Subject: Carlsbad Field Office Class 1 Permit Modification Notifications to the Waste Isolation Pilot Plant Hazardous Waste Facility Permit Number: NM4890139088-TSDF

Class 1 Permit Modification Notifications

**Waste Isolation Pilot Plant
Carlsbad, New Mexico**

WIPP Permit Number - NM4890139088-TSDF

Figure D-5-NFB
Fire-Water Distribution System with Building 416

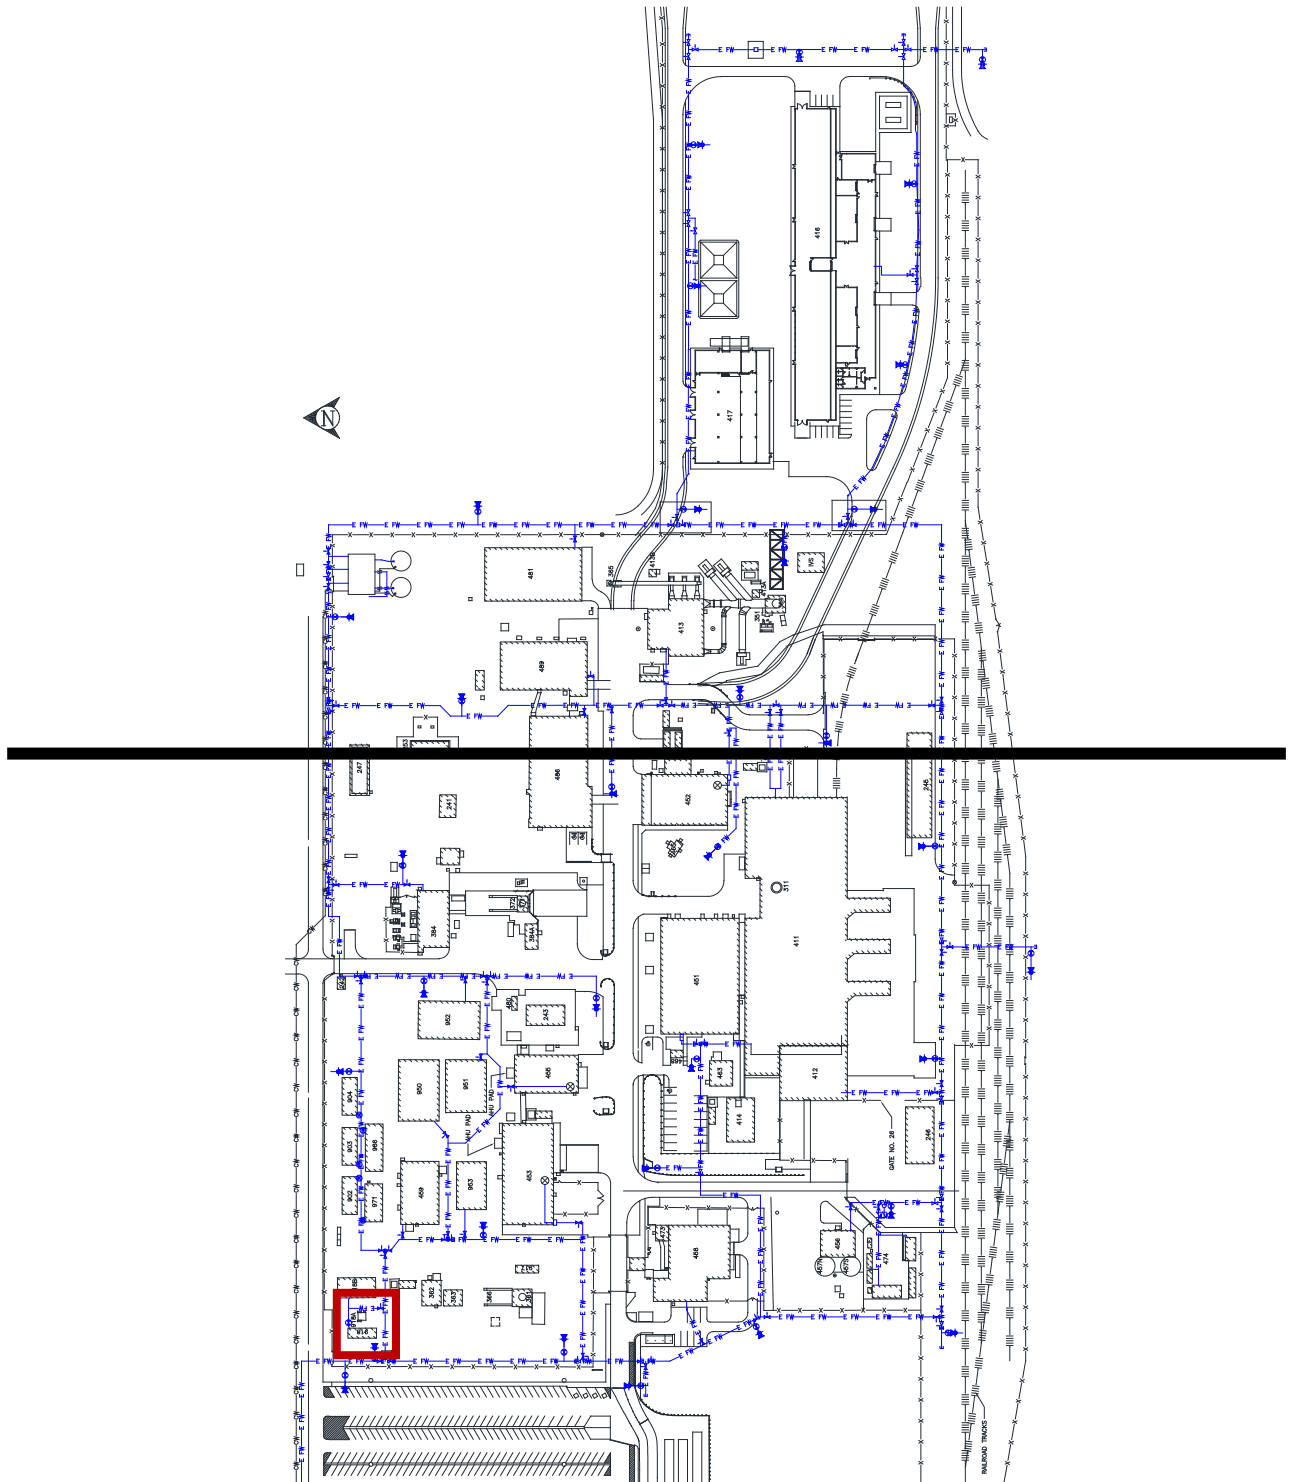
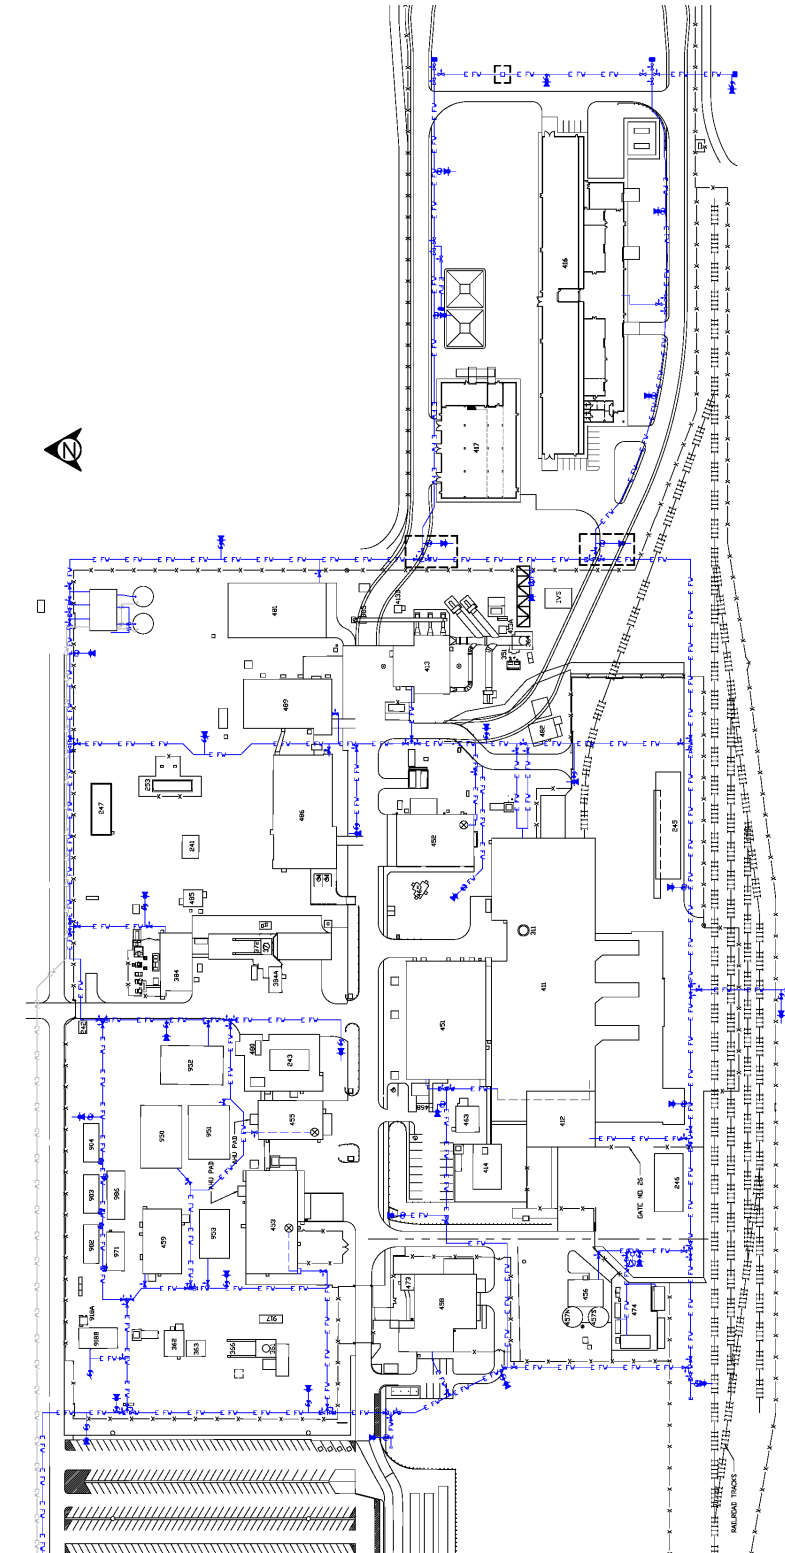
- Attachment D, Figure D-5, *Fire-Water Distribution System*
- Attachment D, Figure D-5-NFB, *Fire-Water Distribution with Building 416*
- Attachment D, Figure D-6, *WIPP On-Site Assembly Areas and Off-Site Staging Areas*
- Attachment D, Figure D-6-NFB, *WIPP On-Site Assembly Areas and Off-Site Staging Areas with Building 416*

In the process of constructing the temporary fence, Building 918A was relocated to the northeast corner of building 918B and Building 918 was removed. All figures depicting the overall site layout have been updated to incorporate the new location of Building 918A and the removal of Building 918 for completeness and accuracy of the Permit.

Figure D-6
WIPP On-Site Assembly Areas and Off-Site Staging Areas

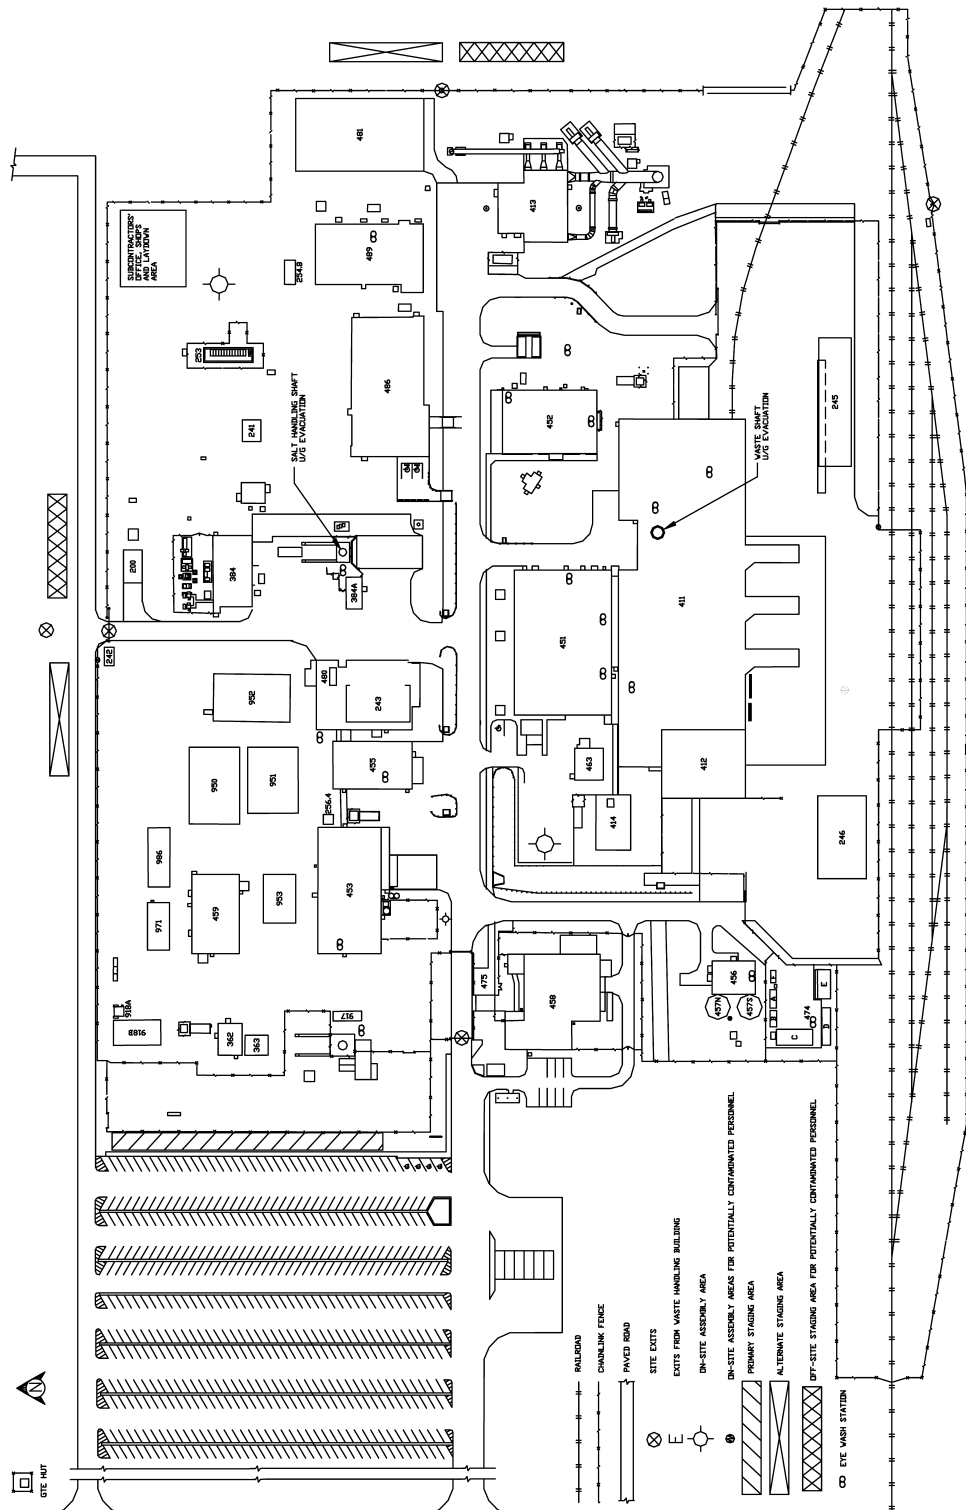
- Attachment A4, Figure A4-2, *WIPP Traffic Flow Diagram*
- Attachment D, Figure D-1, *WIPP Surface Structures*
- Attachment D, Figure D-5, *Fire-Water Distribution System*
- Attachment D, Figure D-6, *WIPP On-Site Assembly Areas and Off-Site Staging Areas*

A temporary fence has been constructed pursuant to Permit Part 2, Section 2.6.2., *Barrier*, in the northwest corner of the PPA to facilitate construction work at the Air Intake Shaft (**AIS**). The temporary fence is located within the current PPA fence as shown in the updated Figures A4-2, D-1, D-5, and D-6. The temporary barrier is seven feet high and topped with three strands of barbed wire for a total height of eight feet, and contains no normal access point or points of entry to the active portion of the facility (i.e., the portion of the facility where hazardous waste management activities are performed).

Figure D-8
WIPP Site Evacuation MapRoutes

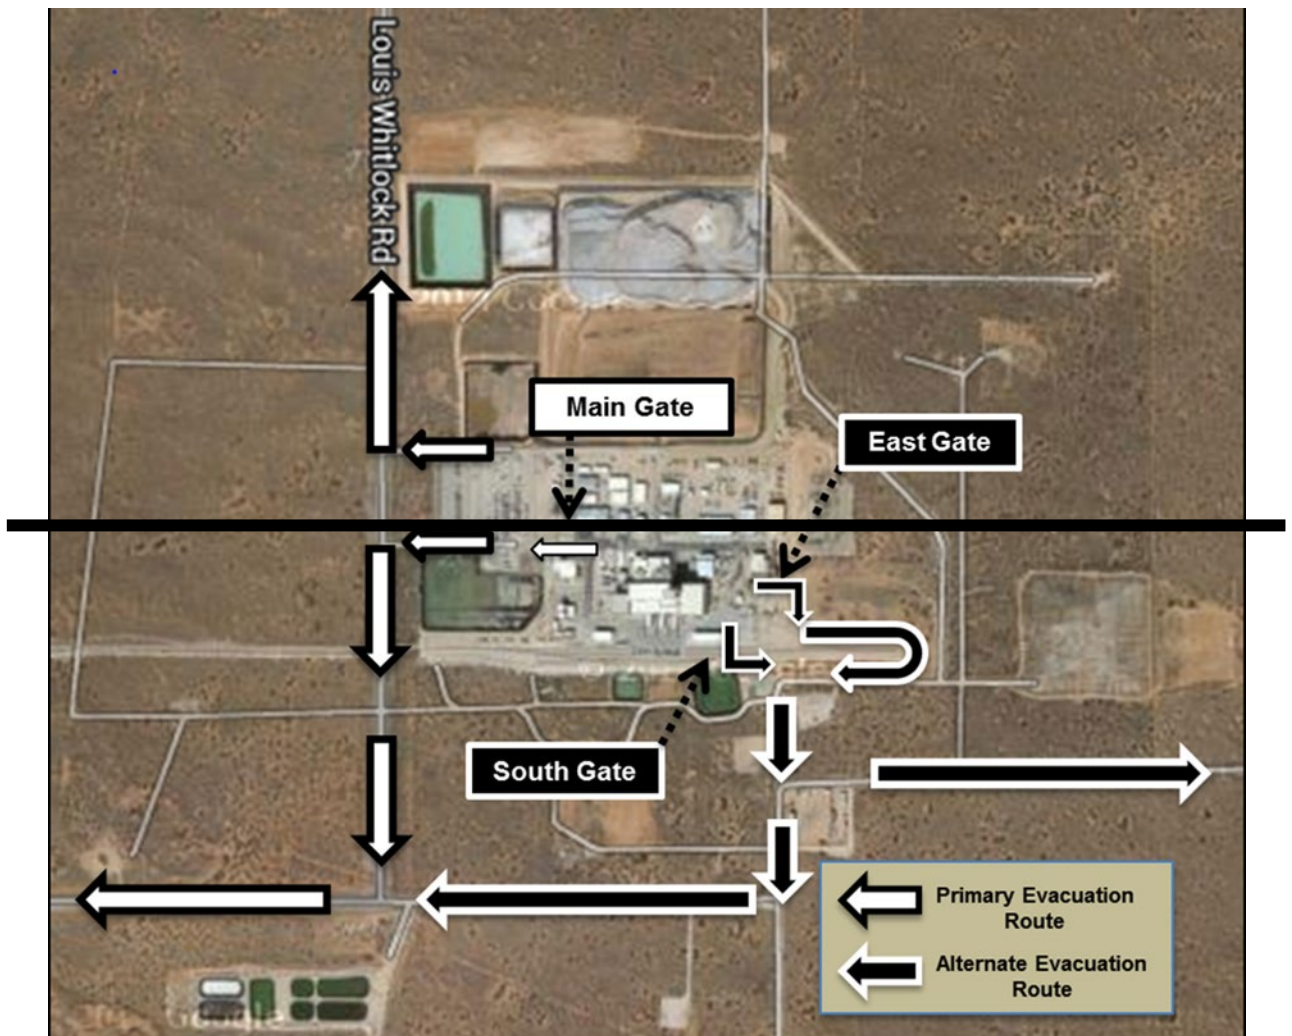
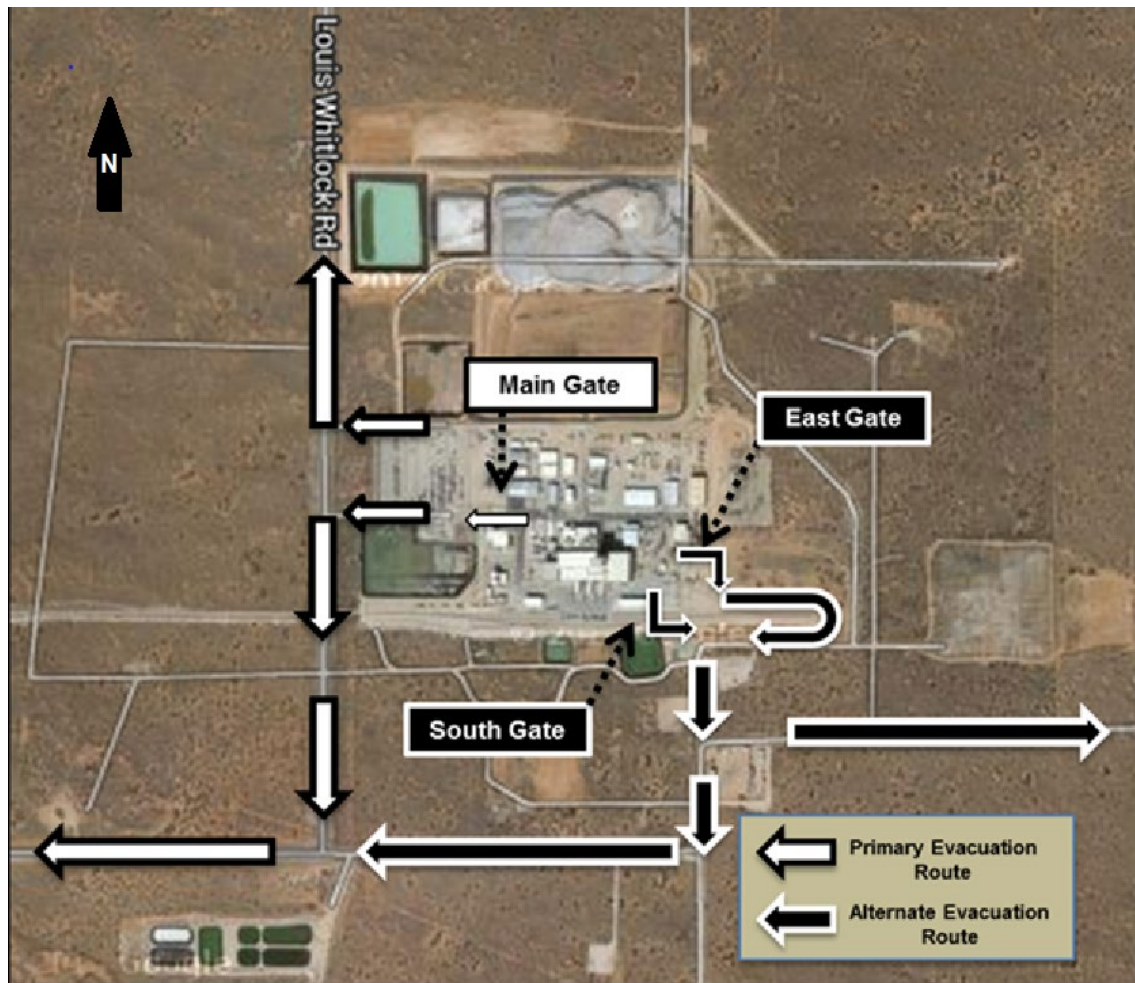
- Replaces Figure D-8 with updated figure incorporating directional north arrow
- Changes Figure D-8 *WIPP Site Evacuation Routes* title to *WIPP Site Evacuation Map*
- Adds Figure D-8a, *WIPP Site Evacuation Routes* to reflect and incorporate recent changes to implementing documents of the *WIPP Emergency Management Plan*
- Updates the Permit text in Sections D-8a, *Surface Evacuation On-site and Off-site Staging Areas* and D-8e, *Further Site Evacuation*, to clarify emergency event evacuation and figure references
- Adds Figure D-8a *WIPP Site Evacuation Routes* to the List of Figures

In addition to the changes due to the temporary barrier construction, Figure D-8, *WIPP Site Evacuation Routes* has been replaced with an identical figure incorporating a directional north arrow and renamed *WIPP Site Evacuation Map*. Figure D-8a, *WIPP Site Evacuation Routes*, has been added to Attachment D to be consistent with the current implementing documents contained in the *WIPP Emergency Management Plan*. Figure D-8a is a satellite image depicting the WIPP site and highlighting the evacuation roads for further site evacuation. These changes are needed to ensure consistency between the Permit and the current *WIPP Emergency Management Plan* implementing documents.

Figure D-8a
WIPP Site Evacuation Routes

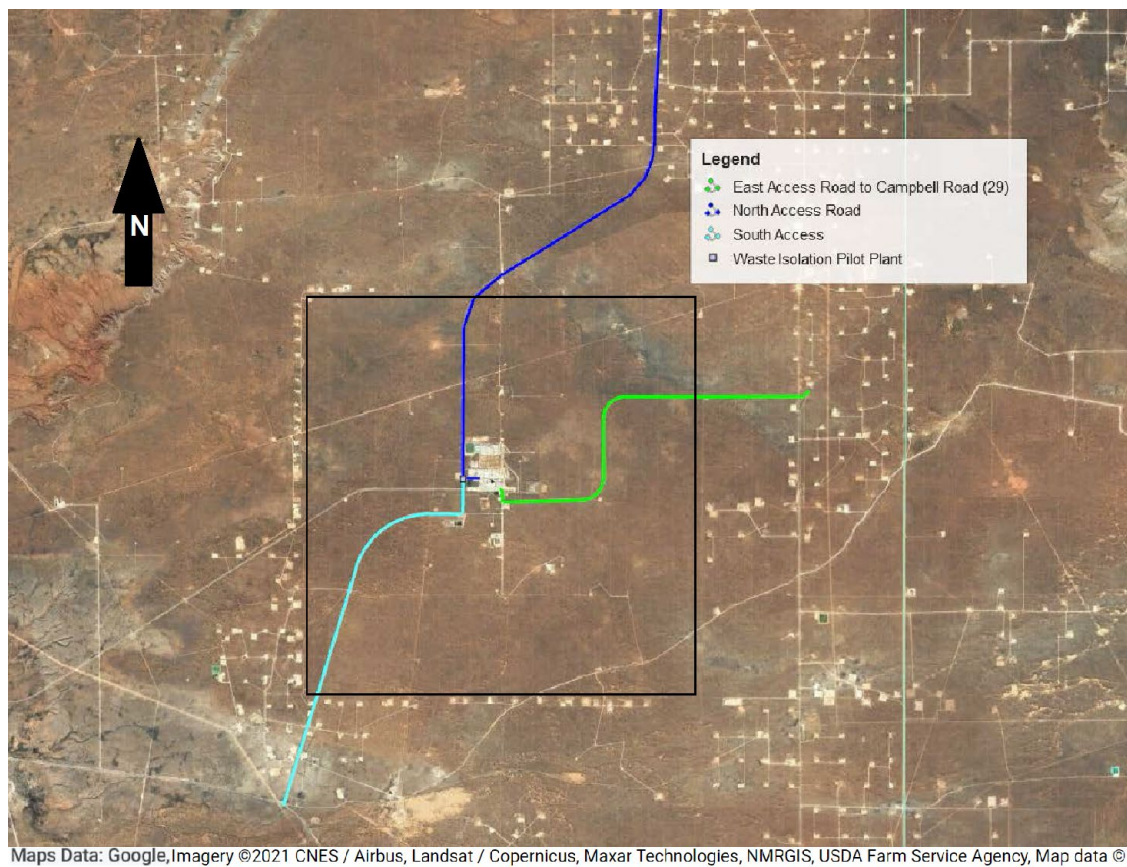
In addition to the changes to Figure D-8 (the title change and adding a directional north arrow) and adding Figure D-8a, Sections D-8a, *Surface Evacuation On-site and Off-site Staging Areas*, and D-8e, *Further Site Evacuation*, of the Permit text have been updated to reflect the changes made to the figures in the current *WIPP Emergency Management Plan*. These updates include adding the description of the south evacuation gate in Section D-8a, *Surface Evacuation On-site and Off-site Staging Areas*, and distinguishing that the east and south gates are alternate evacuation routes. Updates to Section D-8e, *Further Site Evacuation*, include the addition of the Campbell road evacuation route as a route for further site evacuation and the primary and alternative evacuation routes are depicted in Figures D-8 and D-8a.

evacuation routes from the facility are provided at the south side and the east side of the facility (Figure D-8). Utilization of the alternate evacuation routes leads to either the main DOE north/south access road or Campbell Road, which travels north and intersects with U.S. Highway 62/180. The primary and alternate evacuation routes are depicted in Figures D-8 and D-8a.
